# UNITED STATES PATENT AND TRADEMARK OFFICE

APPLICATION NO.	FILING DATE	FIRST NAMED INVENTOR	ATTORNEY DOCKET NO.	CONFIRMATION NO.
10/605,852	10/30/2003	Martin Weiss	20073	2851

<b>Office Action Summary</b>	Application No.	Applicant(s)	
	10/605,852	WEISS, MARTIN	
	Examiner	Art Unit	
	Vinh T. Luong	3682

Fig. 3

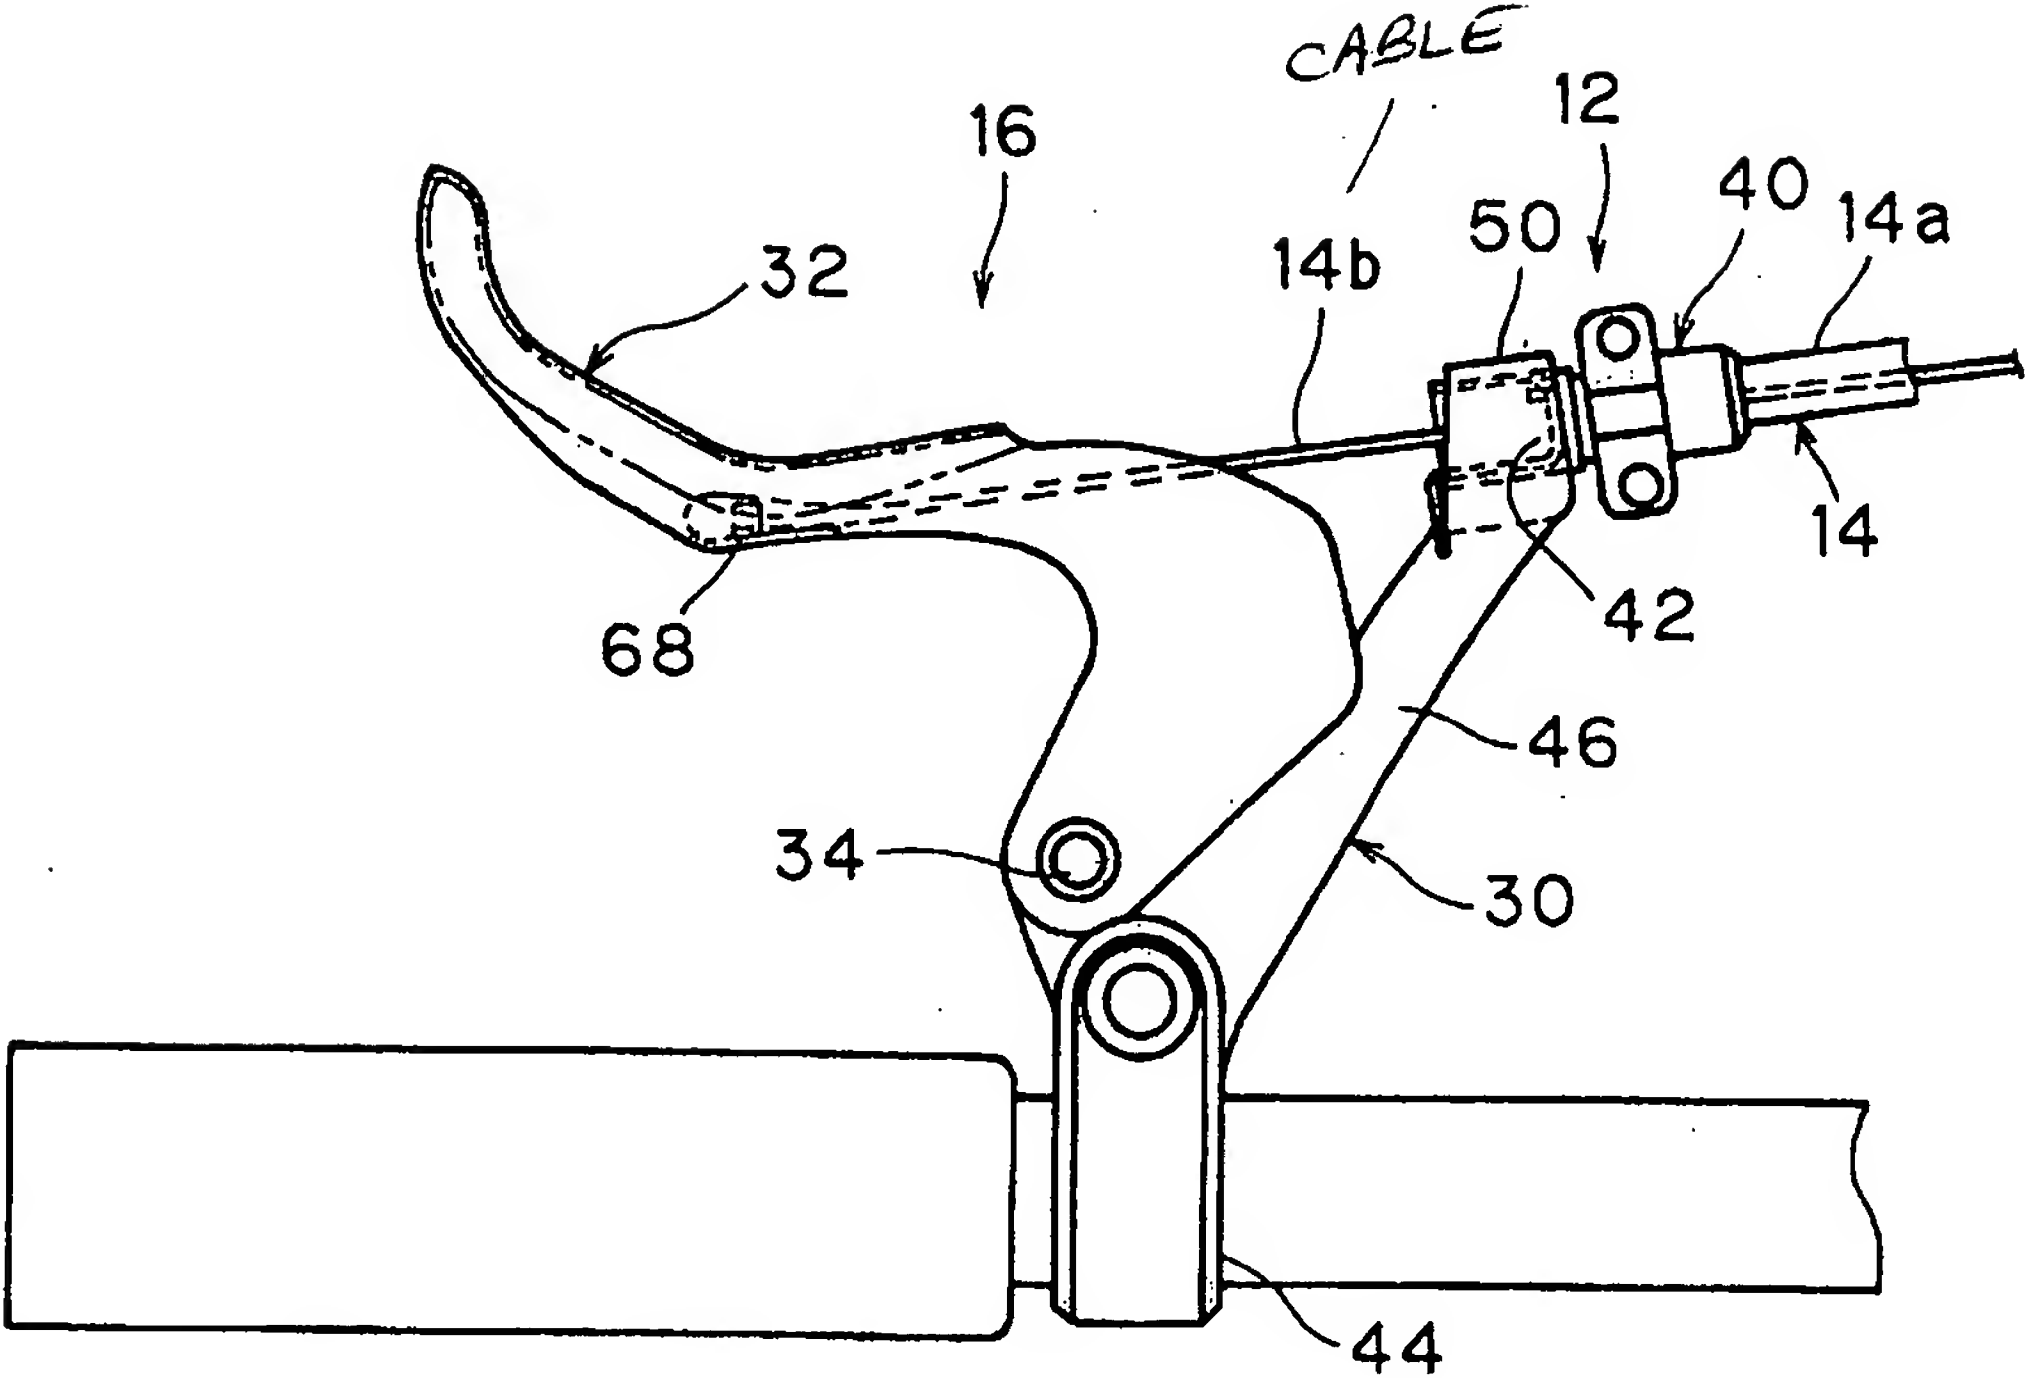
Regarding claim 16, the detent contour 62 has a non-round cross section (since the contour 62 is a longitudinally extending slot) and is configured such that the retention segment 93 has freedom to deflect, the retention segment 93 is configured to extend substantially parallel with the control cable 14b extending through the adjuster 50. See Fig. 3.

Fig. 4

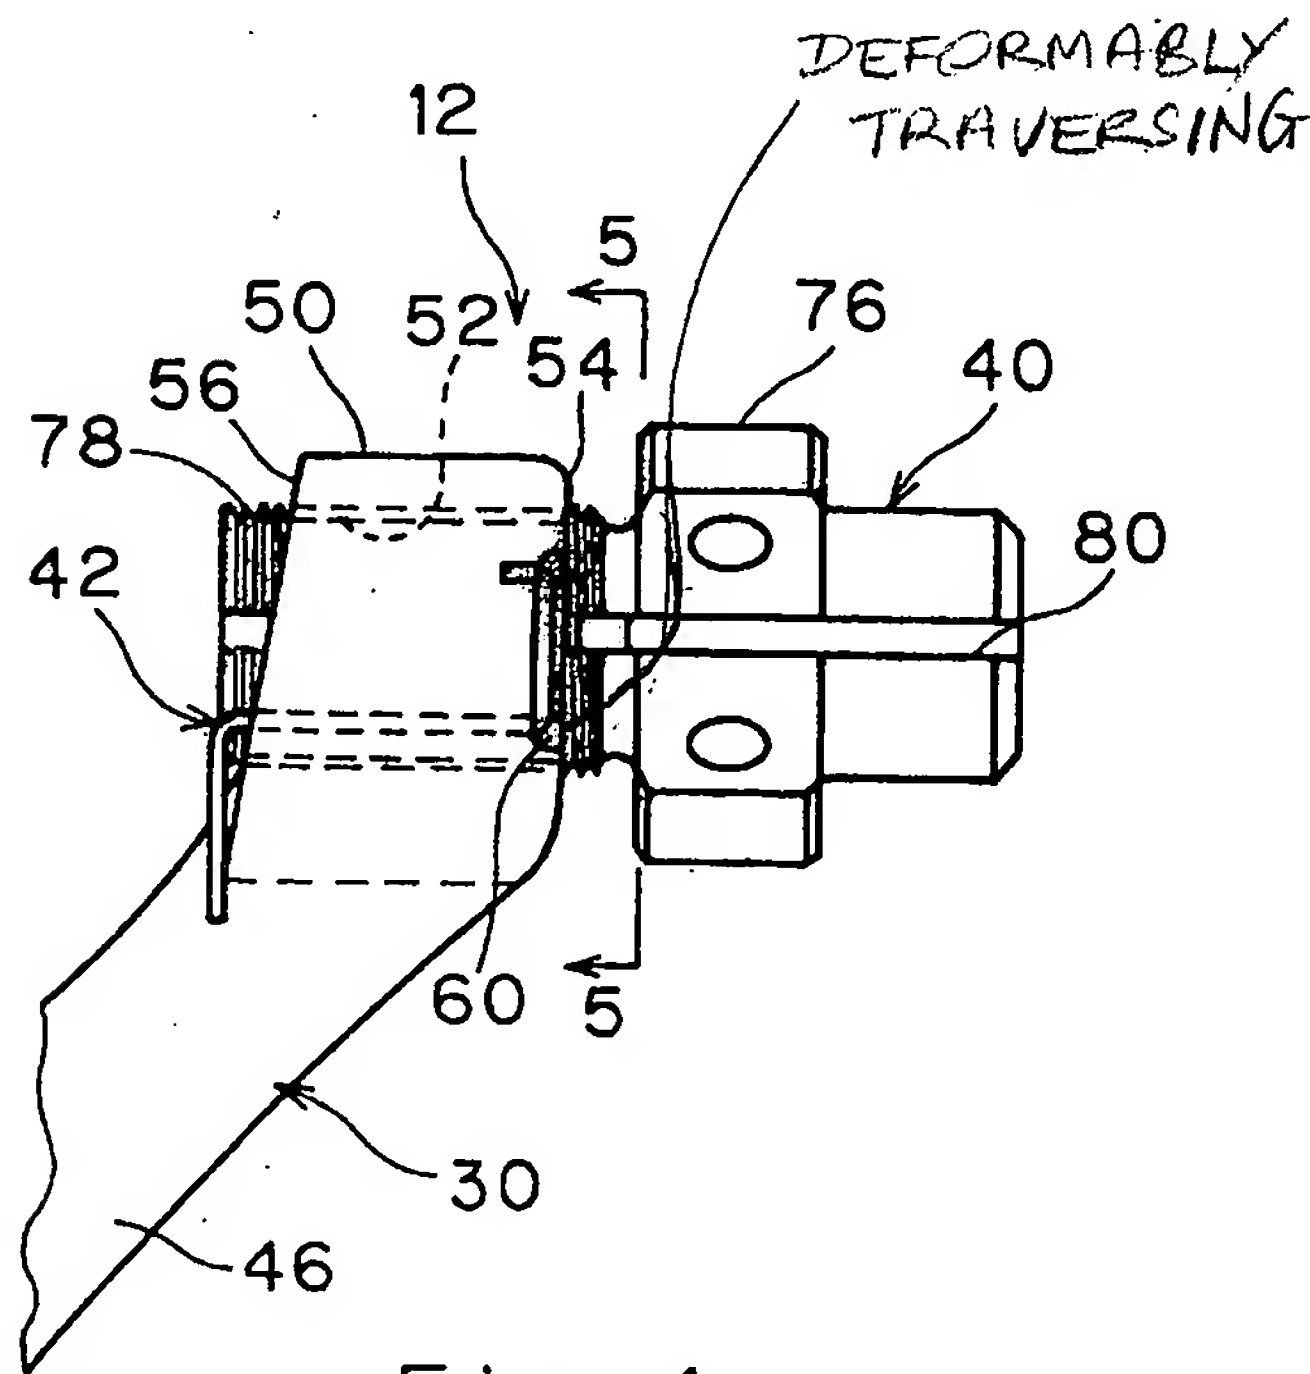
The Examiner respectfully submits that Applicant's contention is unsupported by the substantial evidence in the record. In fact, Yamashita teaches the element 50 that has a detent contour 62 wherein the retention segment 93 of the spring 92 engages the contour 62 *from within* the element 50. Moreover, one end of the retention segment 93, which is connected with the support segment 92/95, is bent transversely to the detent contour as seen in Figs. 4 and 5 so that

By comparison, Yamashita's retention segment 93 is similar to Applicant's retention segment 27. On the one hand, Applicant's retention segment 27 is bent transversely relative to the detent contour 5 at its end that connects to the support segment 26, on the other hand, Yamashita's retention segment 93 is bent transversely relative to the detent contour 62 at its end that connects to the support segment 95/92. Thus, Yamashita teaches the spring 42 comprising the retention segment 93 that deformably traverses (at one end) along the detent contour 62 from within the adjuster 50 as described and claimed.
